GENJI JAPANESE STEAKHOUSE SP 10-47A

GENJI JAPANESE STEAKHOUSE SITE PLAN 10-47A

SUBJECT: Genji Japanese Steakhouse, SP#10-47A,
Traffic Review of Revised Preliminary Site Plan

TO: MARK SPENCER, PLANNER
FROM: BRIAN COBURN, P.E.; ENGINEERING MANAGER *BTC*
SUBJECT: GENJI STEAKHOUSE, REVISED PRELIM SITE PLAN # 10-47A
DATE: FEBRUARY 17, 2011

Standard Parking Island Design with minimum 8' width

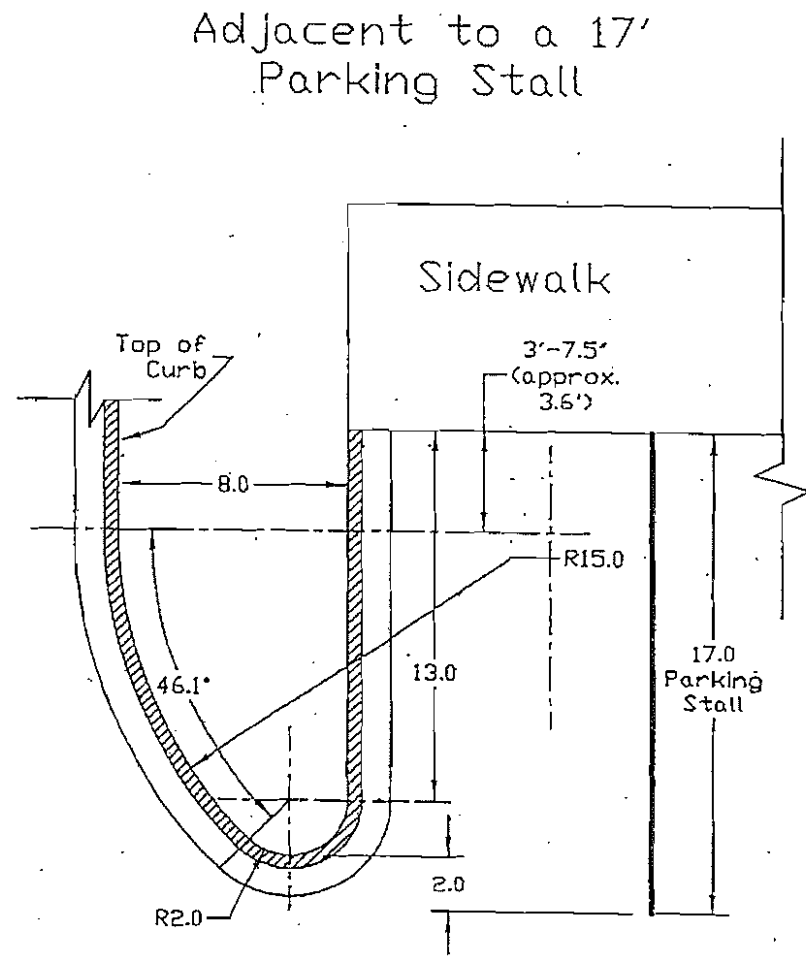
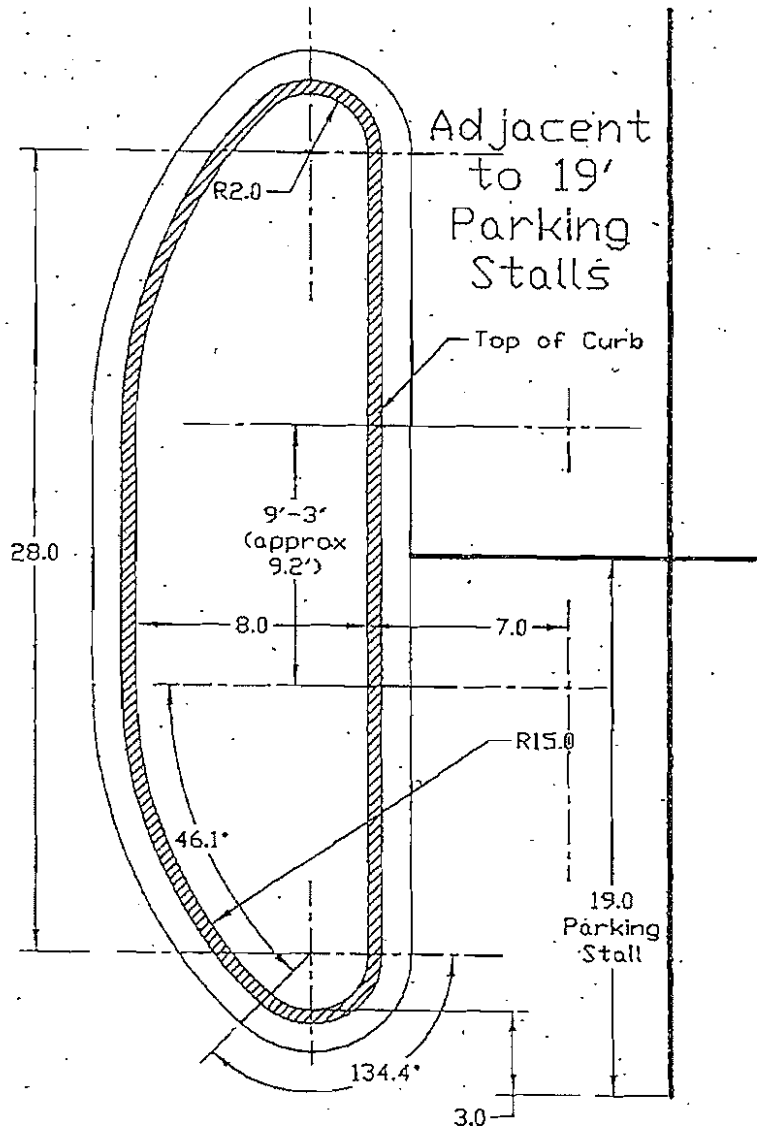
10. The proposed end islands have not been dimensioned, but it is clear that they do not comply with the requirements of the Novi Zoning Ordinance (Section 2506.13), at least in so far as the required setback from the parking lot aisle. Our standard detail for the most common island configuration is attached for the applicant's convenience. **All islands need to be redesigned to meet the basic standards shown in this detail; that is, a 2-3-ft setback from the aisle, and at least an 8-ft width, 15-ft main radius, and a 2-ft minor radius. All back-of-curb radii on the plan should be dimensioned, either as "typical" for a standard (symmetrical) island, or as proposed in locations not incorporating the standard island. To provide adequate room for the required dimensioning, consideration should be given to using a larger scale (say 1 inch = 30 ft).**

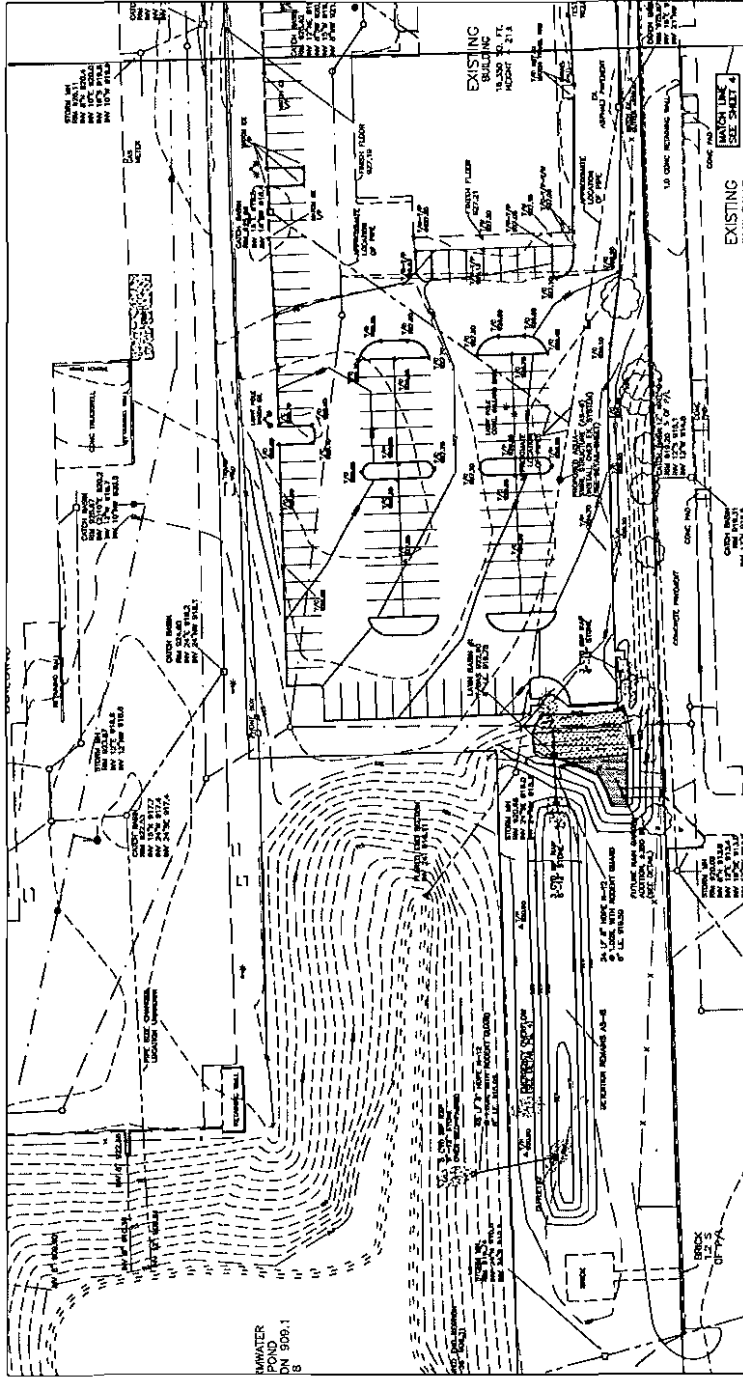
This memo is a supplement to the plan review letter that was issued by the Engineering Division on February 10, 2011. As you recall, the Engineering Division was unable to recommend approval of the revised preliminary site plan (SP 10-47A) because of a conflict between the location of the proposed storm water management facilities and the landbanked and future parking areas.

The applicant's engineer has provided the attached plan sheets which have revised the location of the proposed rain garden, thus removing the conflict with the landbanked parking. The applicant has also proposed the removal of the future parking area that was proposed by others.

With these revisions to the plan, the Engineering Division can now recommend approval of the revised preliminary site plan subject to conditions 2 through 24 of our February 10, 2011 review letter.

RAIN GARDEN DESIGN:

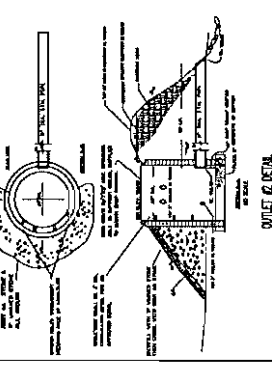
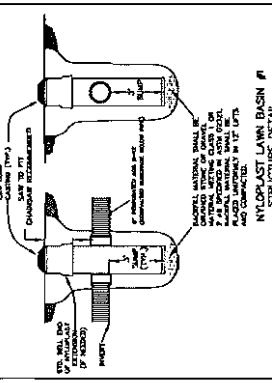
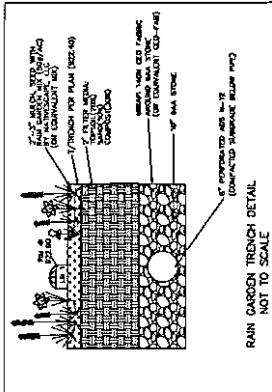
USE 1 YEAR PEAK FLOW THROUGH EXISTING SYSTEM.
SEE CALCULATIONS AS-SHOWN (TREAT TO 0.1 CFS AS CFS) ON SHEET 1. SEE ATTACHED DRAINAGE CALCULATIONS THROUGH EXISTING PIPE NETWORK.
